Re: Genesis Solar Energy Project; 09-AFC-8

Docket No. 09-AFC-8

**TESTIMONY OF MATTHEW F. HAGEMANN
ON BEHALF OF THE
CALIFORNIA UNIONS FOR RELIABLE ENERGY
ON HAZARDOUS MATERIALS AND WASTE MANAGEMENT OF
THE GENESIS SOLAR ENERGY PROJECT**

A flow diagram, as follows, is provided in the ROWD as Figure 10:

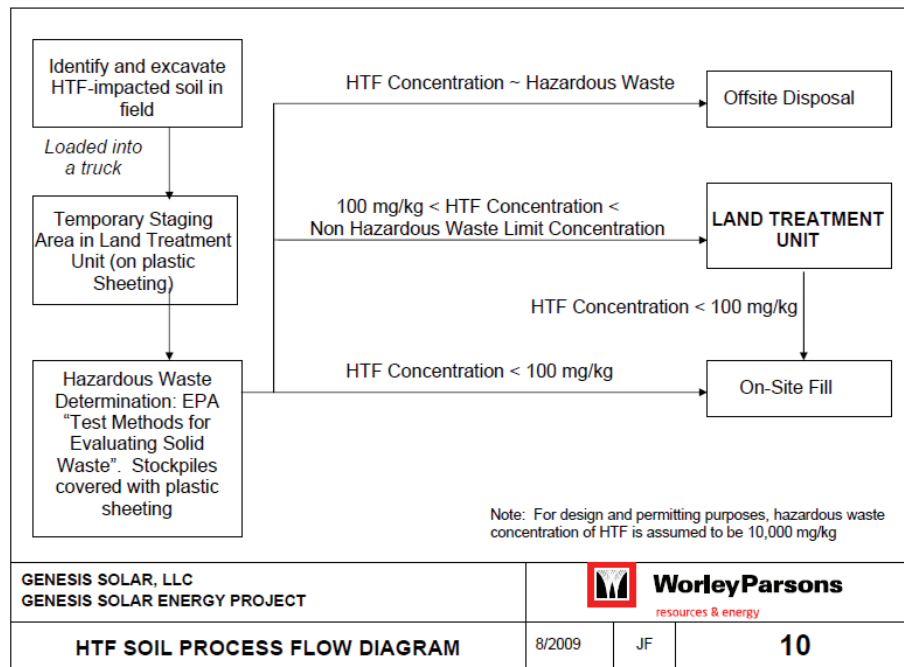
The flow diagram shows that HTF-impacted soil will be placed in the staging area of the LTU without sampling. HTF-impacted soils will be identified (presumably by visual means) and then moved to the LTU prior to sampling.

The staging area of the Project’s LTU does not meet the requirements for a temporary staging area under Section 25123.3(a)(2) of the Health and Safety Code for two reasons. First, the hazardous waste being accumulated would likely contain free liquids. Spills of HTF will generate free liquids at temperatures above approximately 54 degrees Fahrenheit. The ROWD and the Revised SA make no mention of liquid wastes that will be generated when HTF is spilled. Second, contaminated soil would not be “accumulated on an impermeable surface, such as high density polyethylene (HDPE) of at least 20 mills that is supported by a foundation, or high density polyethylene of at least 60 mills that is not supported by a foundation.” The Revised SA states only that HTF-contaminated soil will be “placed on plastic sheeting” pending receipt of analytical results and characterization of the waste material.

The Revised SA must incorporate as conditions of certification all measures necessary for compliance with all cited sections of the California Health and Safety Code.
